SUBJECT: Entergy Nuclear Operations, Inc.
James A. FitzPatrick Nuclear Power Plant
Docket No. 50-333
License No. DPR-59
Emergency License Amendment Request Application for Technical
Specification 3.8.1 Required Action B.4 Completion Time

**JAFP-09-0070
Attachment 1**

**Emergency License Amendment Request Application
for
Technical Specification 3.8.1 Required Action B.4 Completion Time**

ACTIONS

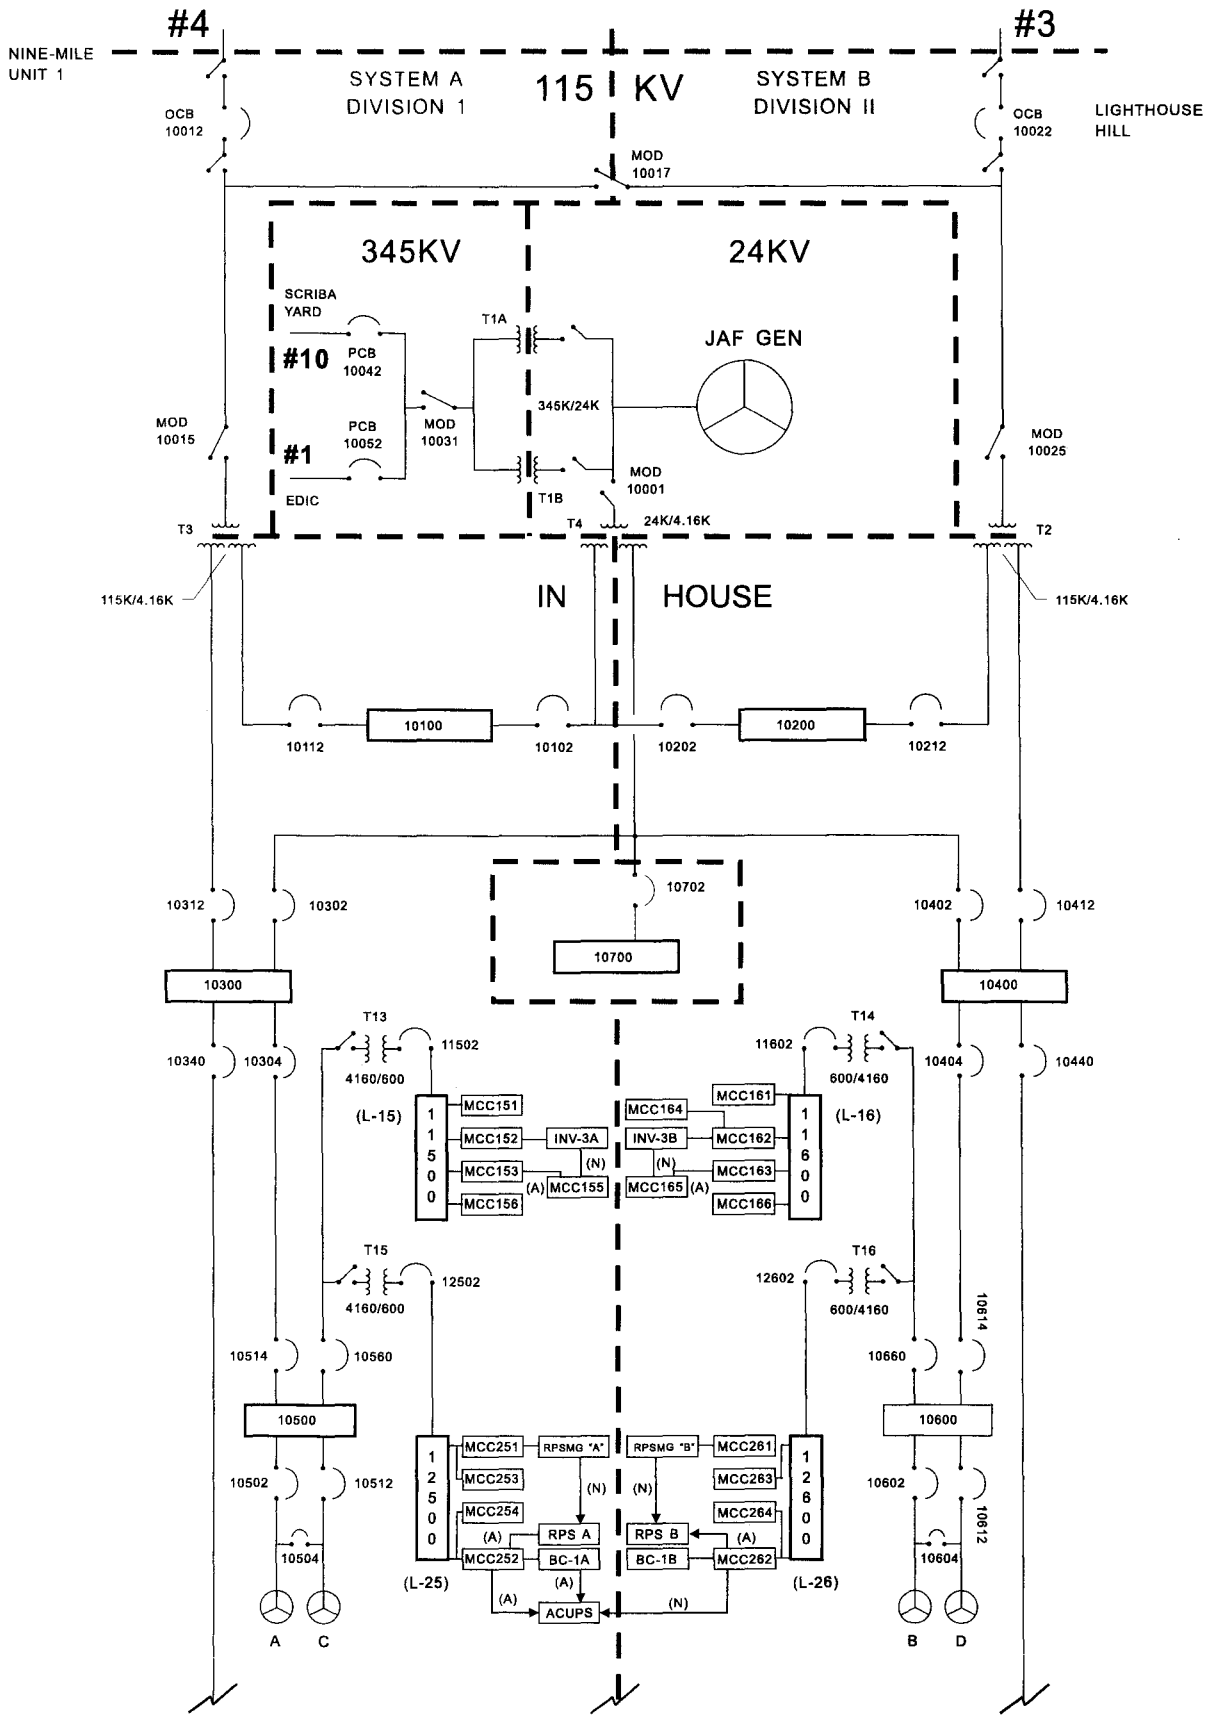
CONDITION	REQUIRED ACTION	COMPLETION TIME
B. (continued)	B.4 Restore EDG subsystem to OPERABLE status.	14 days ⁽¹⁾ <u>AND</u> 21 days from discovery of failure to meet LCO
C. Two offsite circuits inoperable.	C.1 Declare required feature(s) inoperable when the redundant required feature(s) are inoperable. <u>AND</u> C.2 Restore one offsite circuit to OPERABLE status.	12 hours from discovery of Condition C concurrent with inoperability of redundant required feature(s) 7 days
D. One offsite circuit inoperable. <u>AND</u> One EDG subsystem inoperable	----- NOTE ----- Enter applicable Conditions and Required Actions of LCO 3.8.7, “Distribution Systems – Operating,” when Condition D is entered with no AC power source to any division. ----- D.1 Restore Offsite circuit to OPERABLE status. <u>OR</u>	12 hours (continued)

(1) For the “A” EDG subsystem only, the Completion Time that the subsystem can be inoperable as specified by Required Action B.4 may be extended beyond the “14 days AND 21 days from discovery of failure to meet LCO” up to “17 days AND 21 days from discovery of failure to meet LCO”, to support repair and restoration of the 93EDG-C rotor. Upon Completion of the repair and restoration, this footnote is no longer applicable and will expire at 1015 on June 12, 2009.
